October 17, 1978

SUBJECT: POST-LOCA HYDROGEN PRODUCTION FROM MATERIALS INSIDE CONTAINMENT

MEMORANDUM FOR: Robert L. Tedesco, Assistant Director for Plant Systems, DSS  
FROM: W. R. Butler, Chief, Containment Systems Branch, DSS  
SUBJECT: POST LOCA HYDROGEN GENERATION FROM ZINC  
Reference: Memo for R. Tedesco from: S. Pawlicki, "Hydrogen Generation Rates after LOCA," March 15, 1978

MEMORANDUM FOR: W. R. Butler, Chief, Containment Systems Branch, DSS  
FROM: F. Eltawila  
THRU: J. Kudrick, Section Leader, Section A  
Containment Systems Branch  
SUBJECT: HYDROGEN GENERATION IN MARK II CONTAINMENT DUE TO ZINC  
CORROSION  
Reference: Memorandum for W. R. Butler from S. Pawlicki dated  
August 9, 1978

FIGURE 1 H<sub>2</sub> TRANSIENTS FOR PWR DRY CONTAINMENT

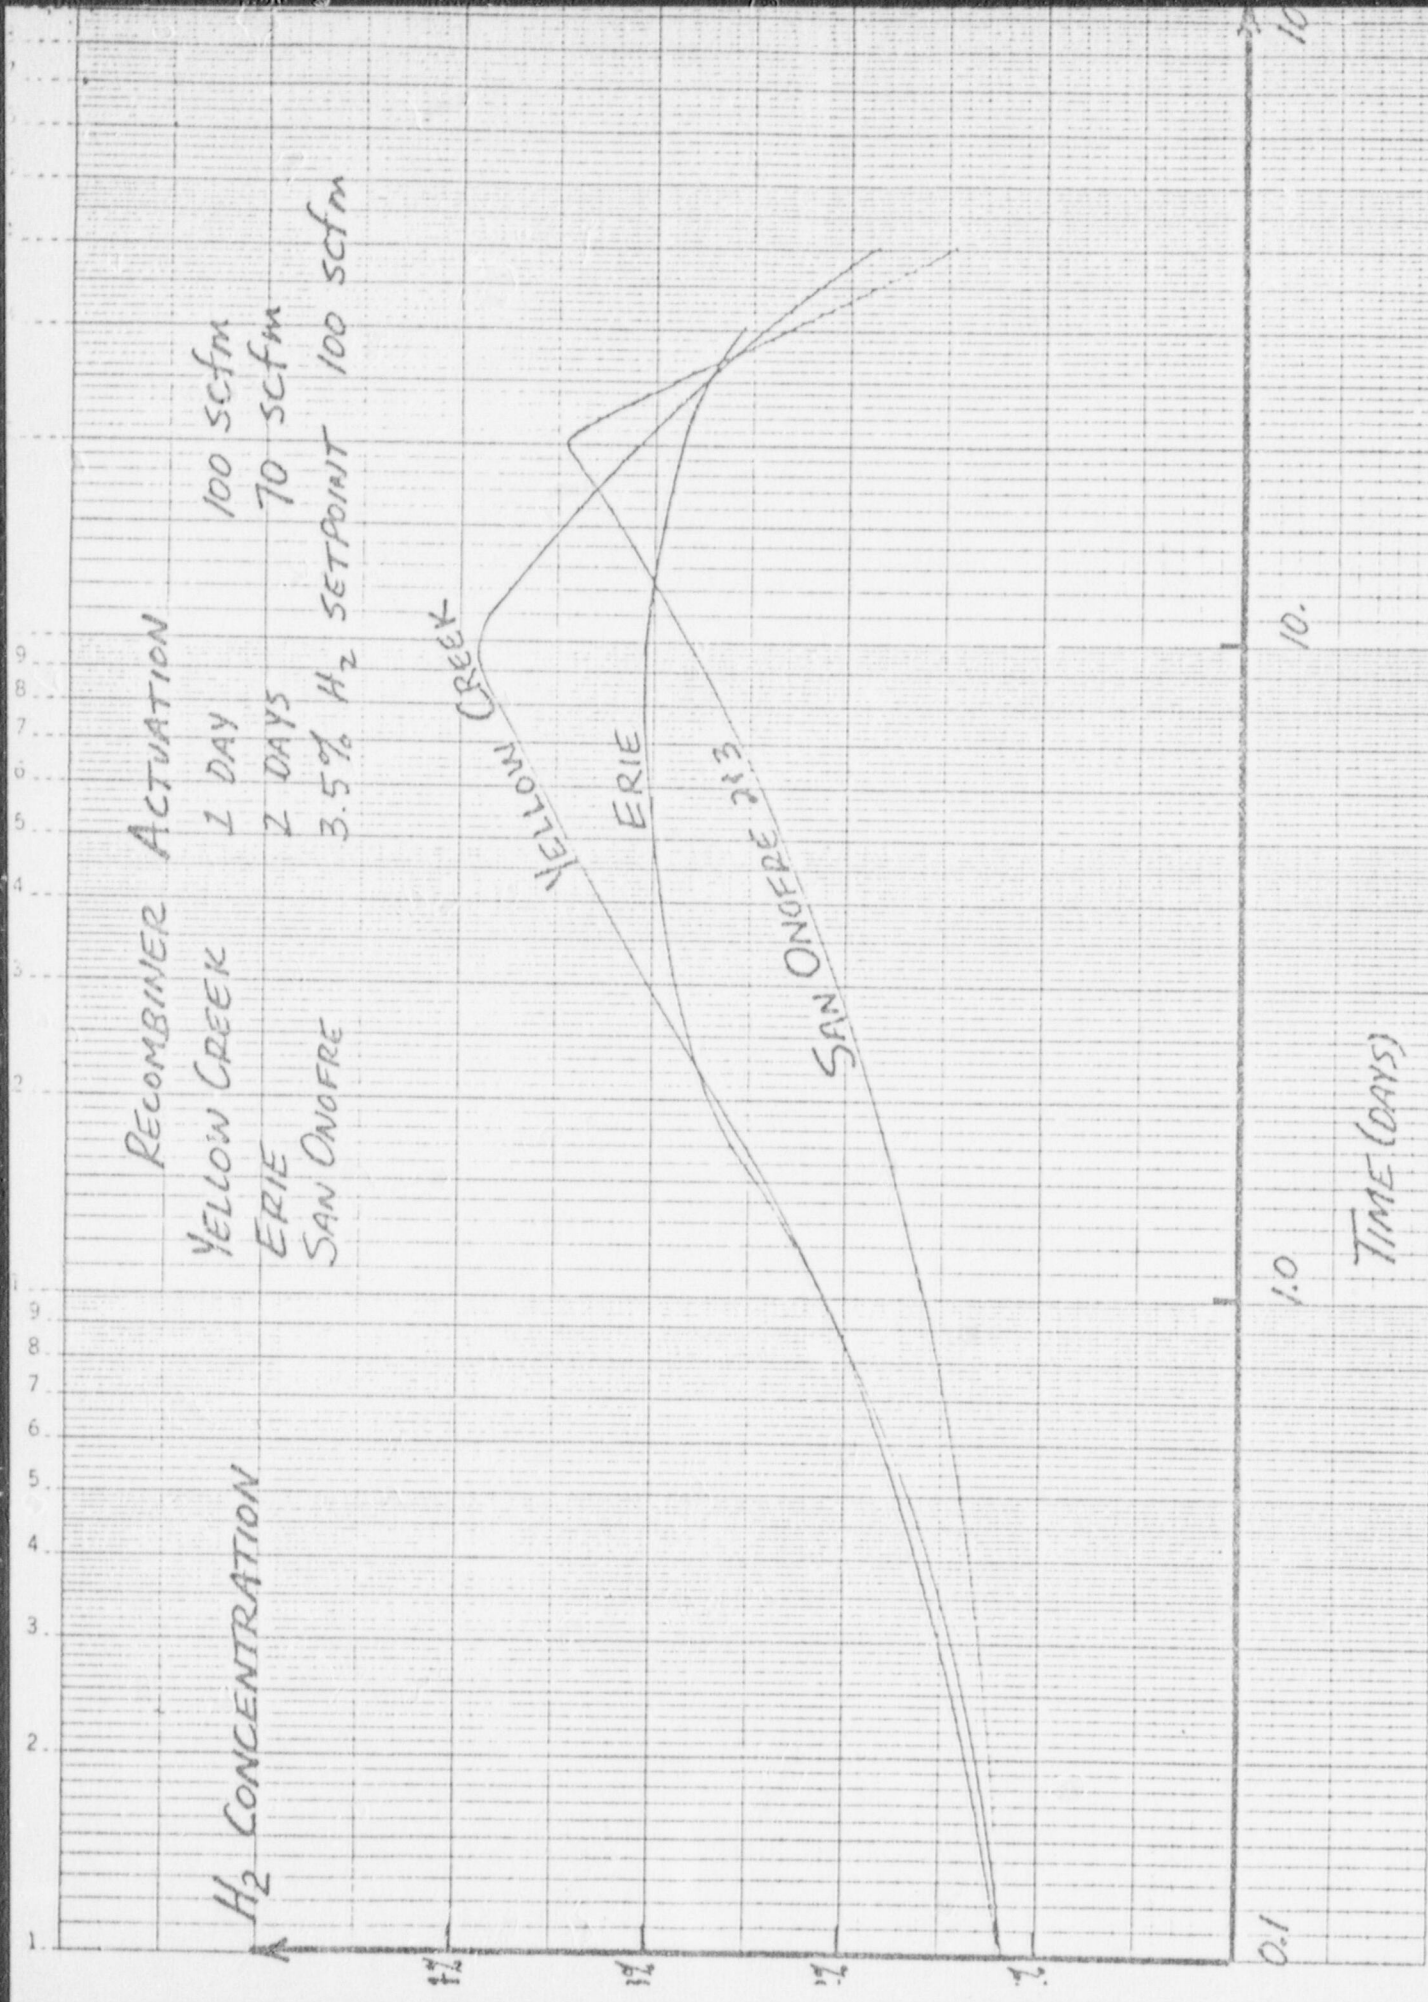
Figure 1 presents the calculated hydrogen concentration transients for the three dry containment plants (PWR) included in the study. For these analyses the recombiner actuation times, shown on Figure 1, were taken from the applicants' SAR, with the exception of the Yellow Creek plant, for which the recombiners were arbitrarily started one day after the postulated LOCA. As can be seen from Figure 1, all of the plants maintain the hydrogen concentration below the lower flammability limit.

FIG. 2

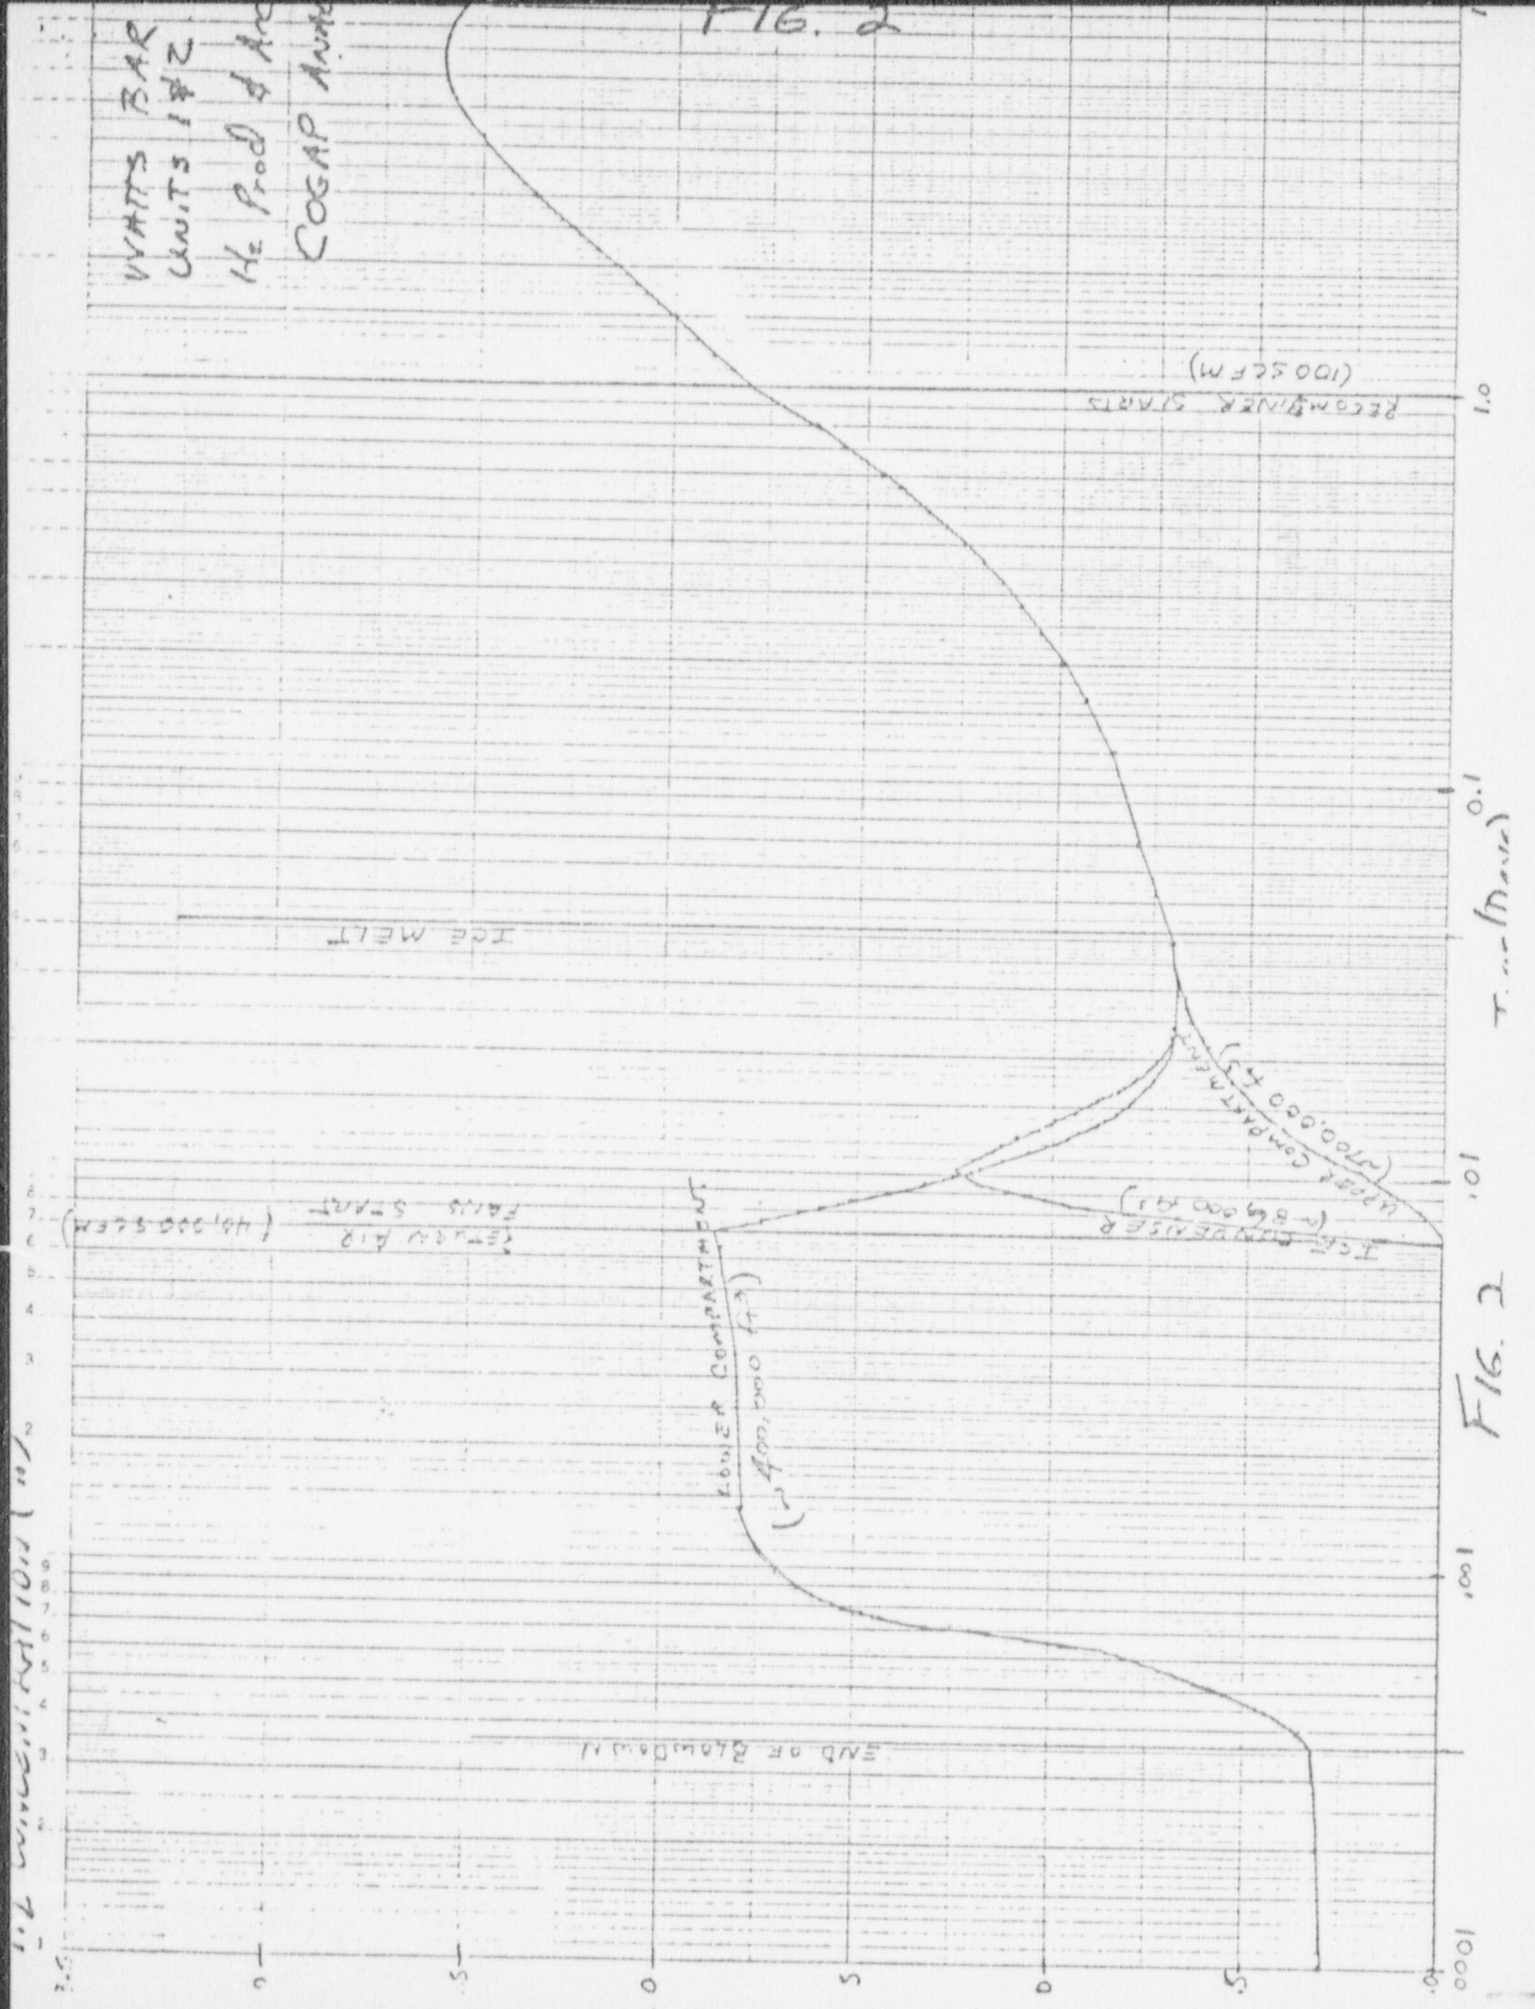
Figure 2 presents the calculated hydrogen concentration transient for the Watts Bar ice condenser containment plant. Even though this plant contains a large mass of zinc, in the form of galvanized metal, the hydrogen concentration is maintained well below the flammability limit. The effect of the large zinc mass is mitigated by the relatively low containment atmosphere temperature post-LOCA, which results in a slower hydrogen generation rate. This lower generation rate can be accommodated by the recombiners.

FIG. 3 HATCH-2

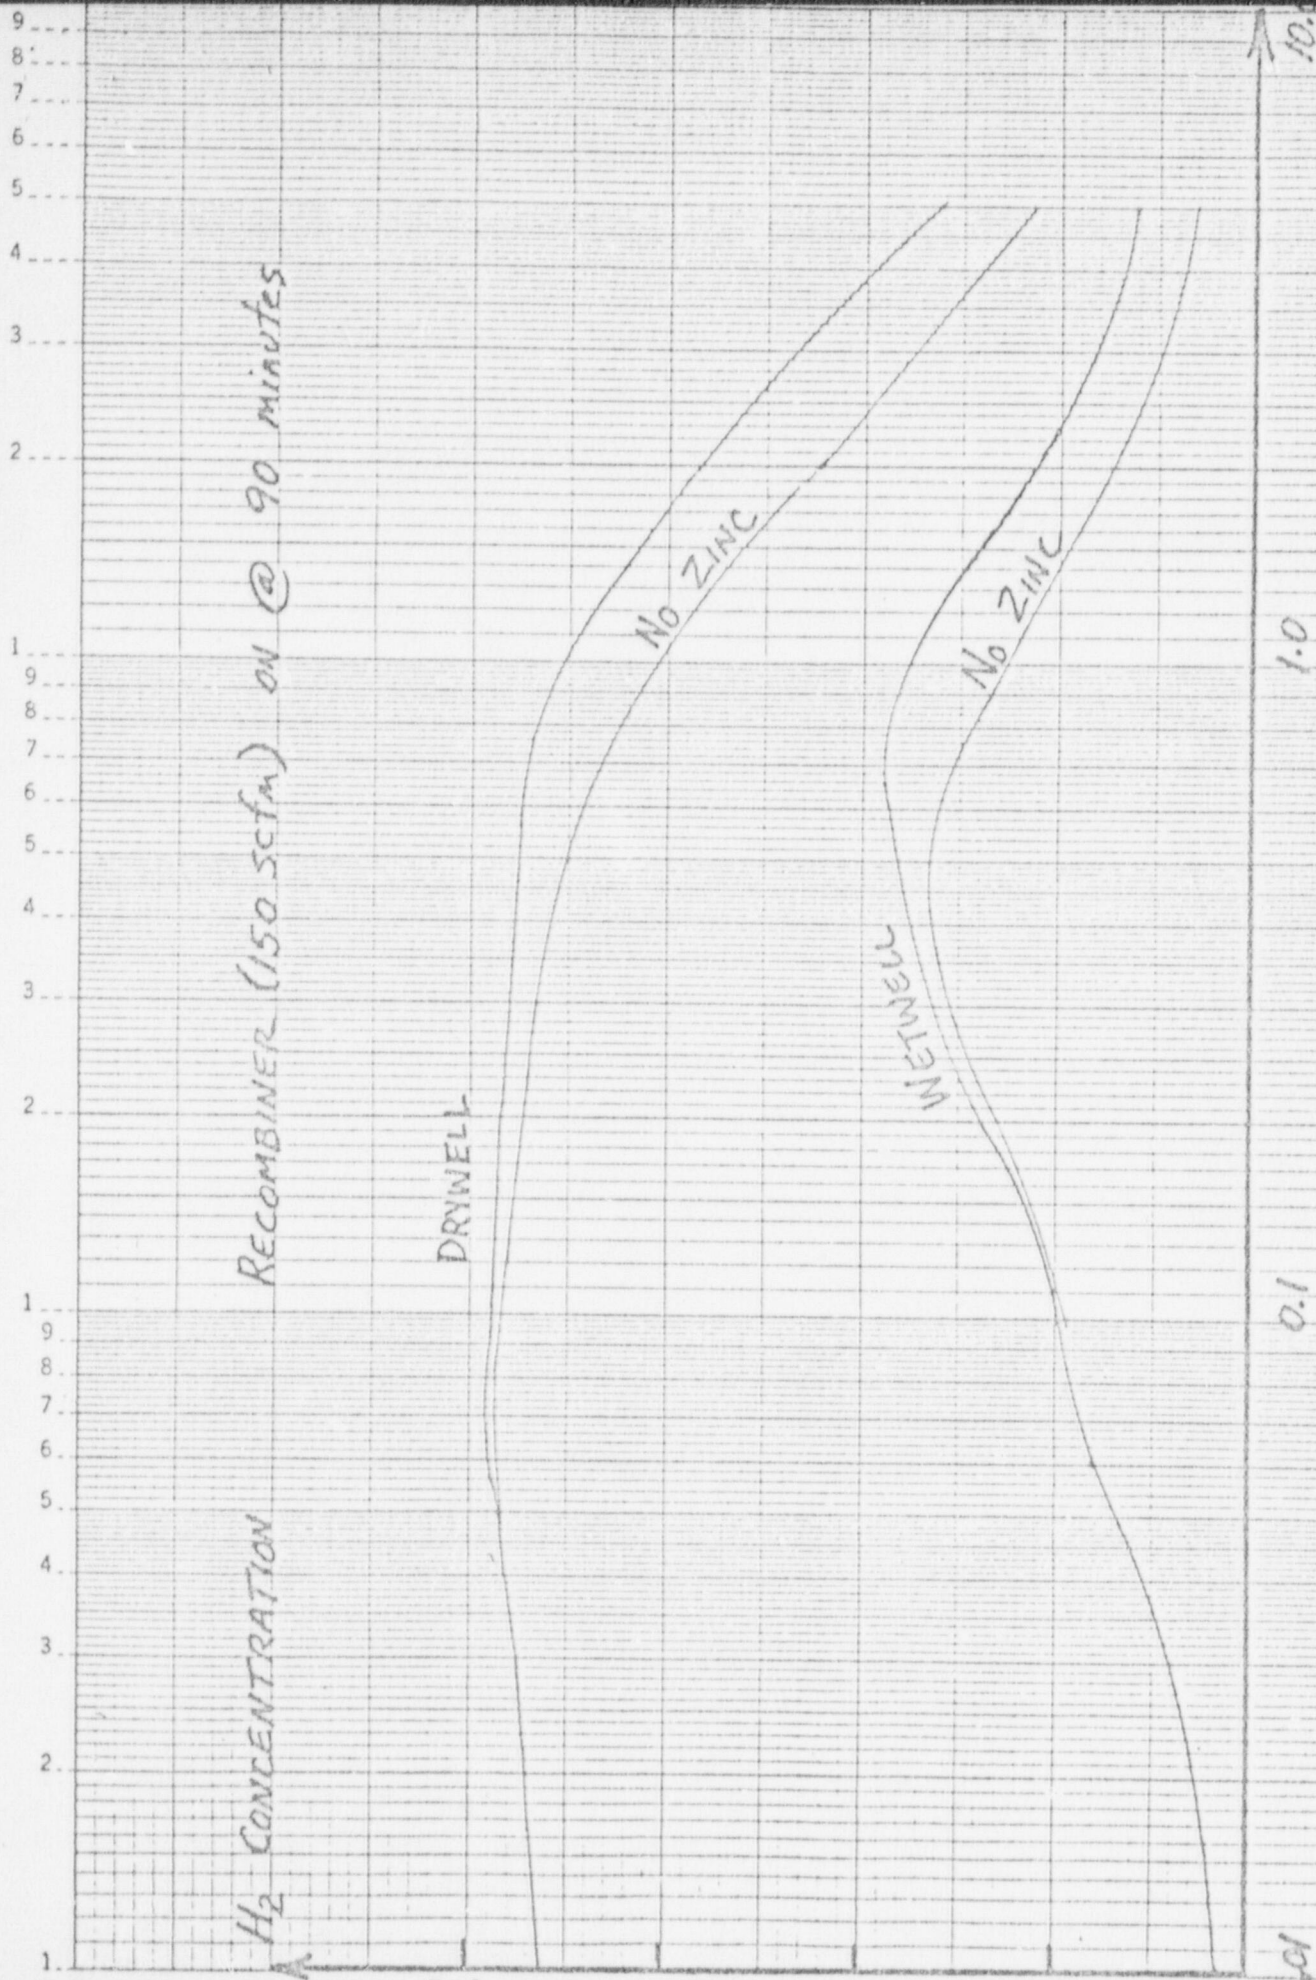
Figure 3 presents the calculated hydrogen concentration transient for the Hatch 2 plant (Mark I containment) using our estimates of zinc inside the containment since this information was not supplied by the applicant. Figure 3 also presents a comparison with a calculated hydrogen transient assuming no zinc was present. Figure 4 shows the post-LOCA temperature transient used to determine the zinc corrosion rates. It is apparent from the analyses performed that the effect of zinc, at least in the manner considered, was minimal for the Hatch 2 plant. This is probably due to the small surface area of zinc assumed to exist in the drywell and the relatively low post-accident temperature transient throughout the containment.
